City of Cambridge

RE: File No. 11606 – 689 Massachusetts Avenue Limited Renovations- Addendum No. 1

Addendum No. 1

A1.0

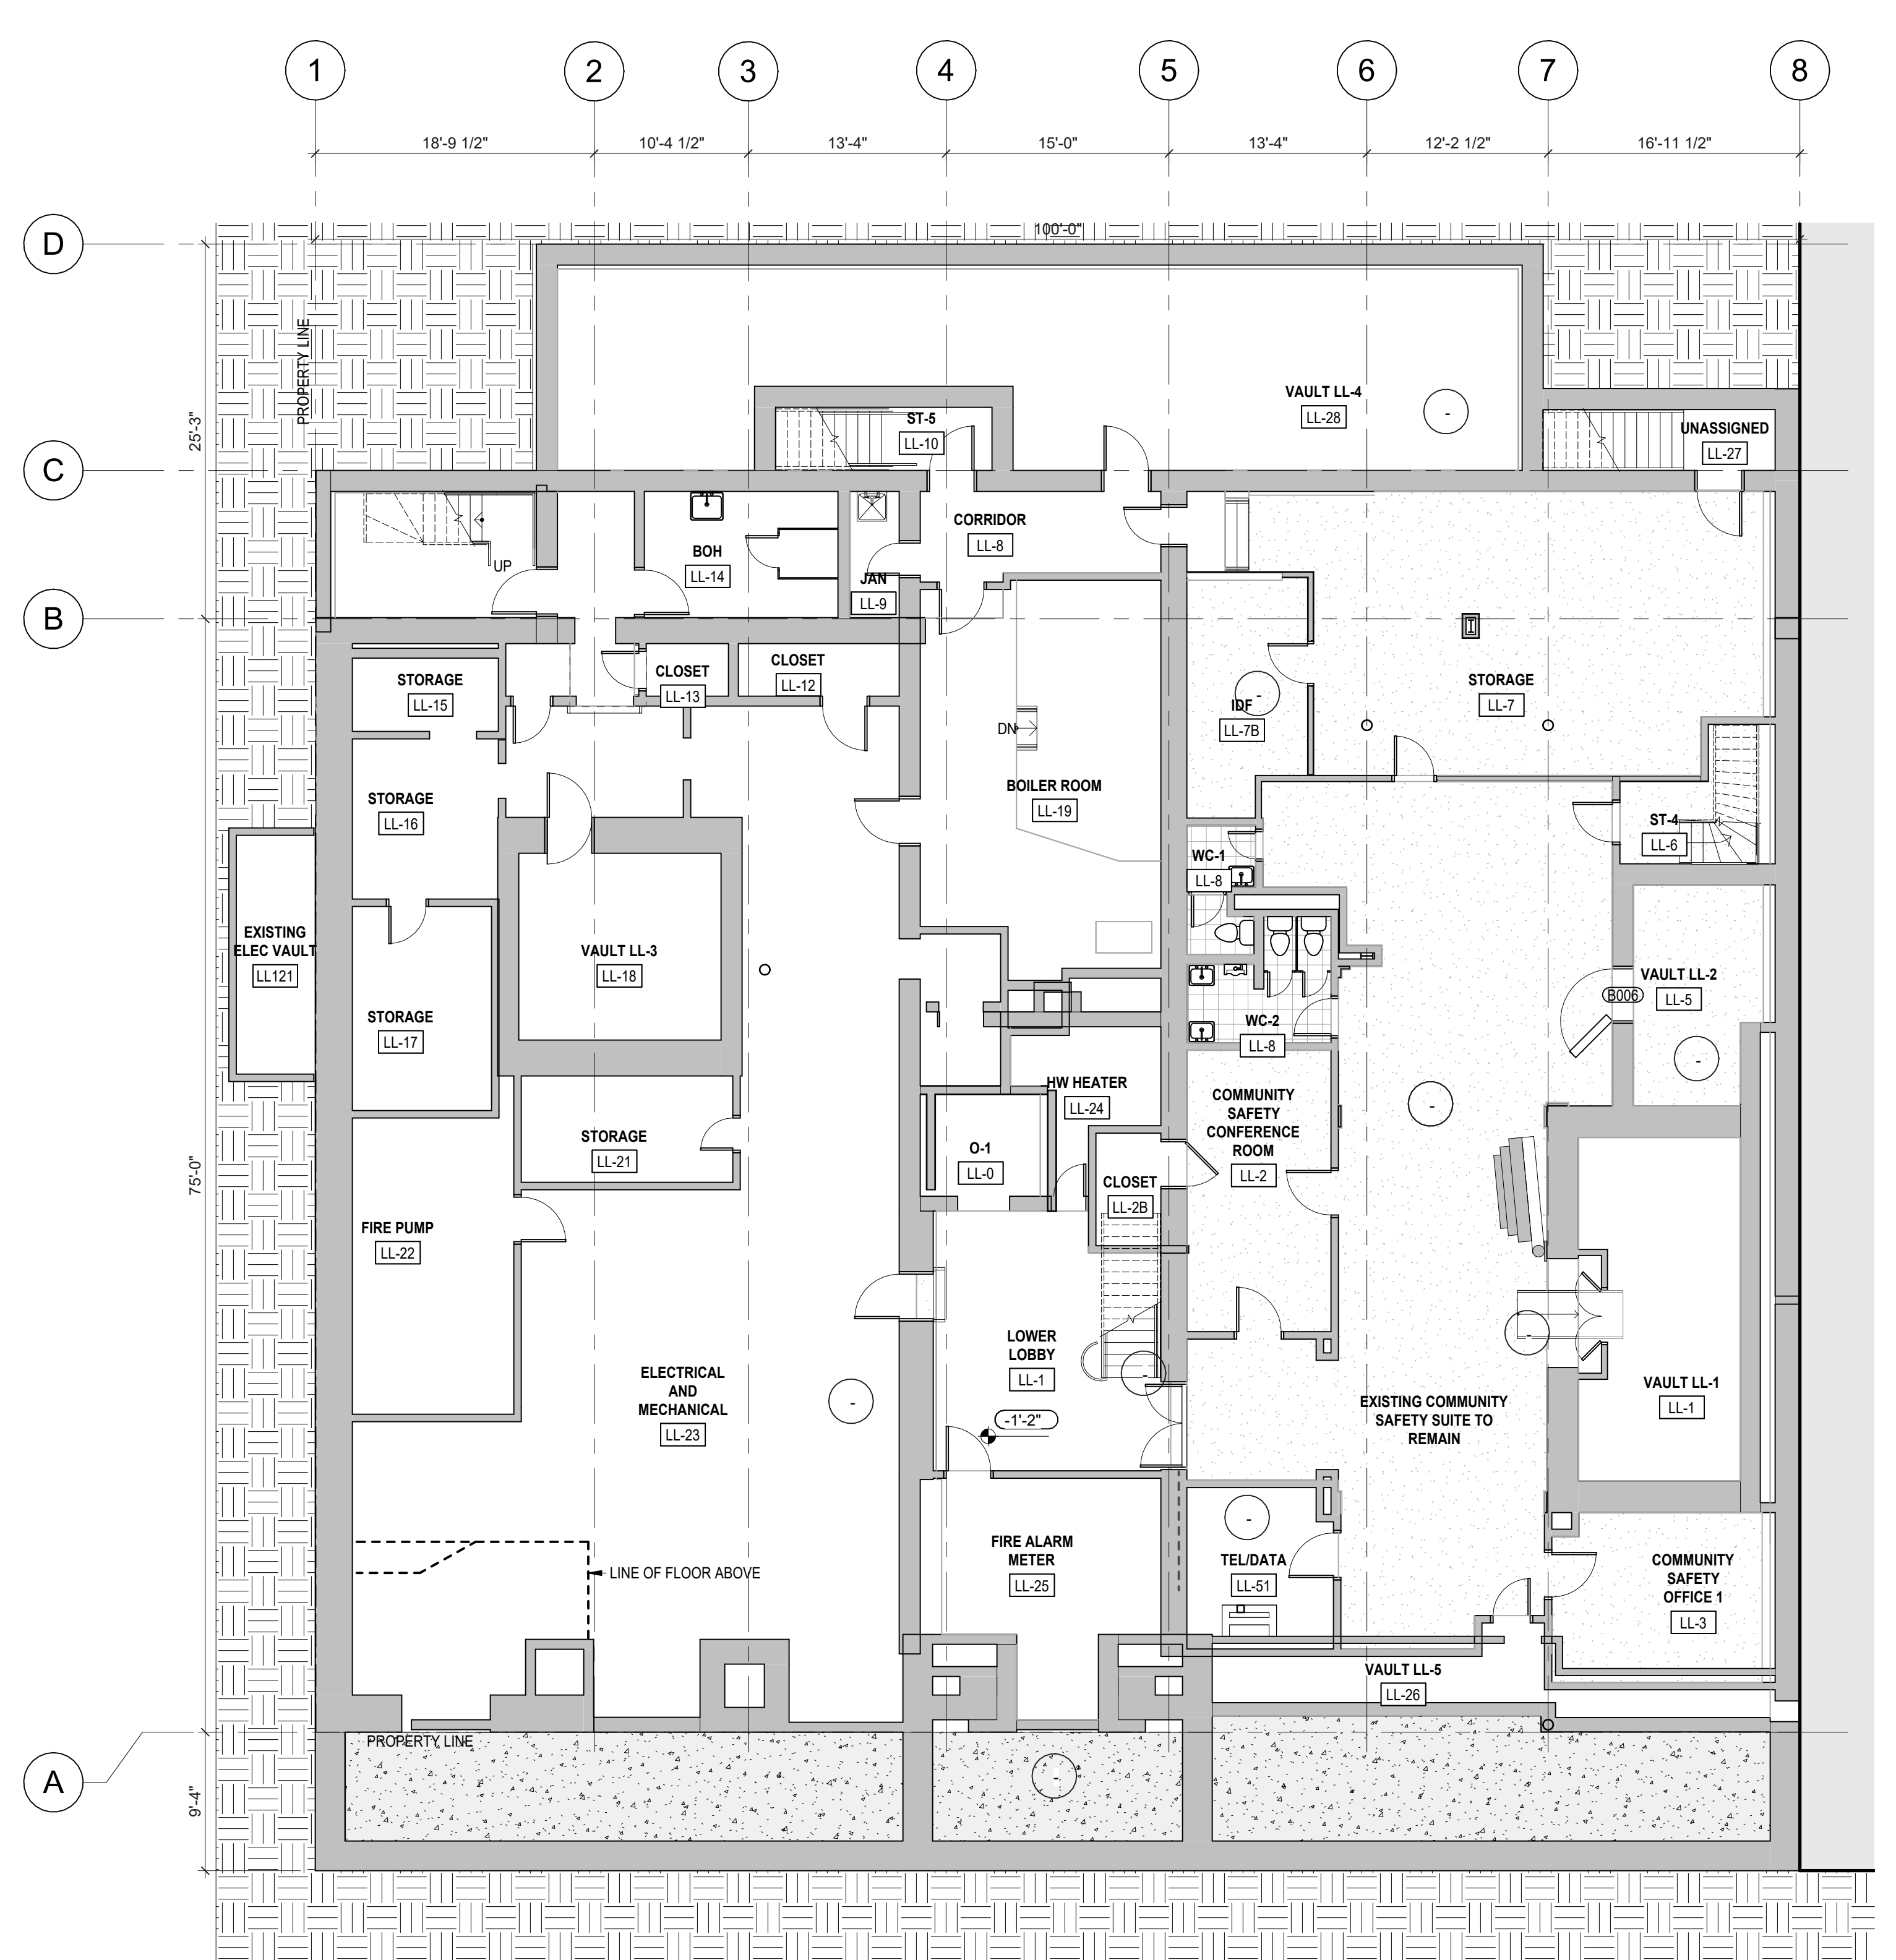
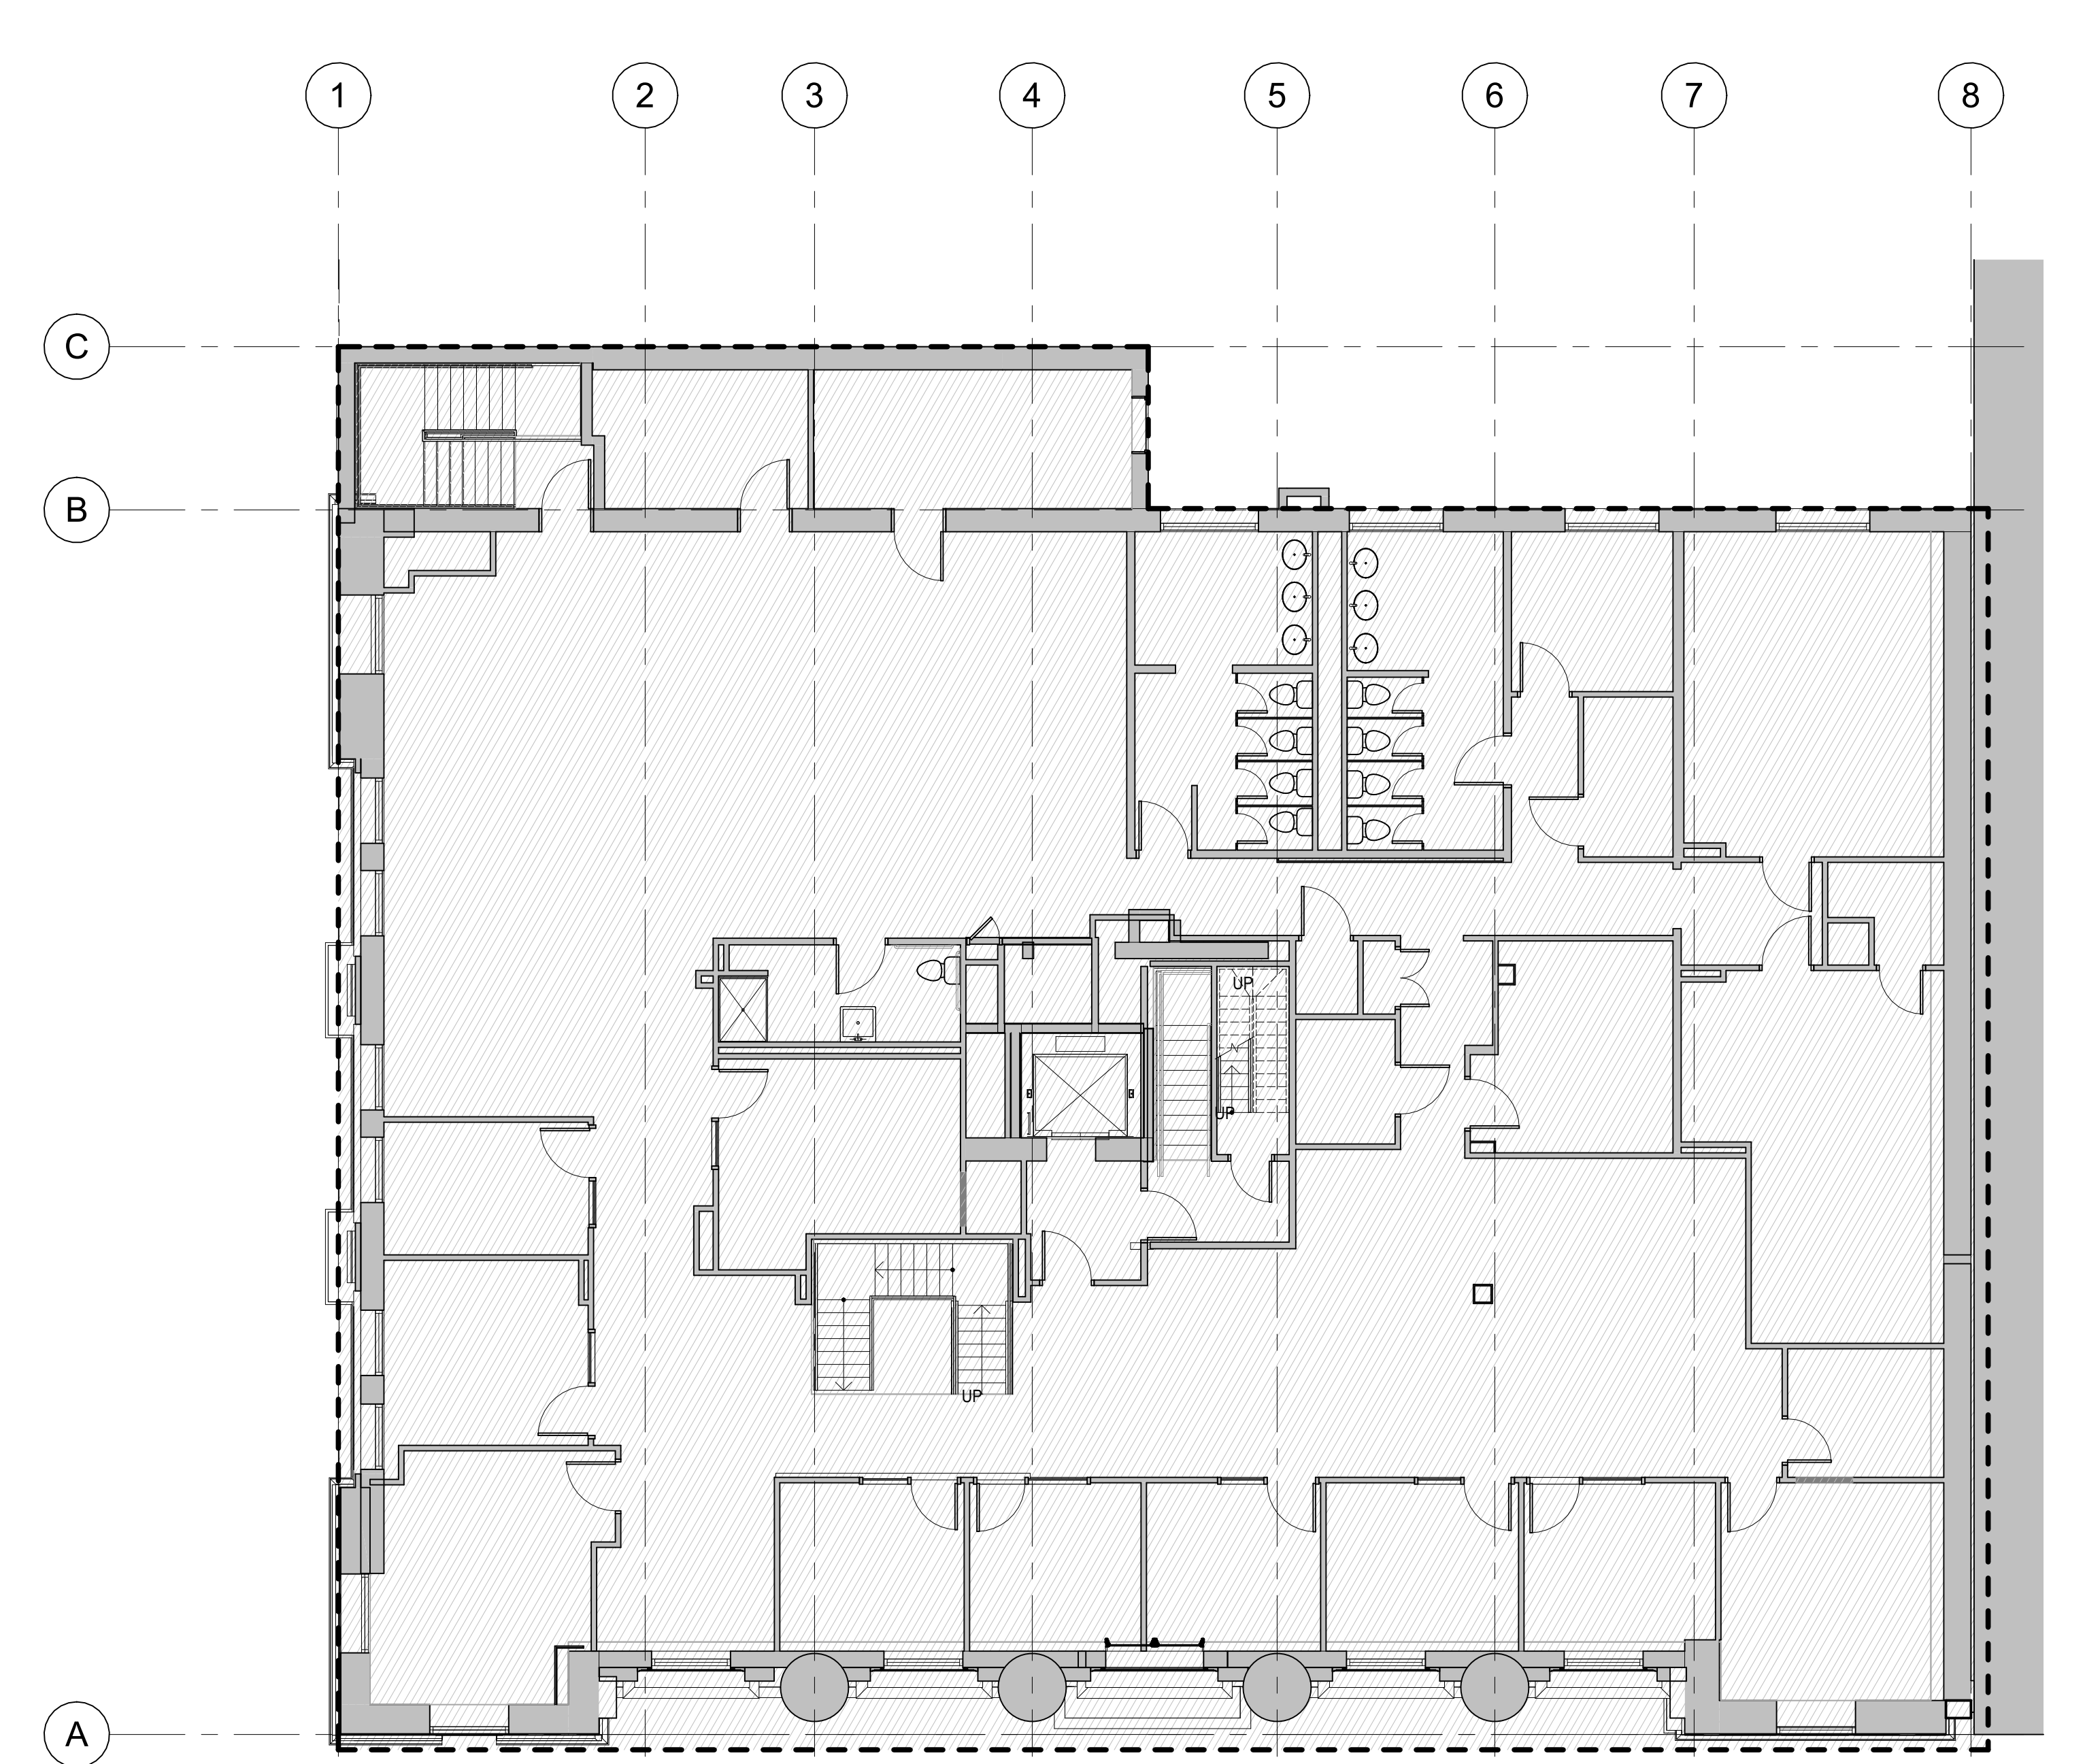
- 1. Drawing A2.1, A2.2 : Add clarifying note for bidders to “Assume replacement of 25% of ACT for existing damaged, stained or missing tiles, typ.” (095110)**
- 2. Drawing A1.0, A1.3, A2.1, A2.2: Clarify note to “Salvage existing ACT at areas required for HVAC scope of work. Replace ACT tiles damaged as part of HVAC scope of work as required” (095110)**

(0510) NOTE: SALVAGE EXISTING ACT AREAS REQUIRED FOR HVAC SCOPE OF WORK. REPLACE ACT TILES DAMAGED AS PART OF HVAC SCOPE OF WORK AS REQUIRED TYP. REFERENCE MECHANICAL DRAWINGS.
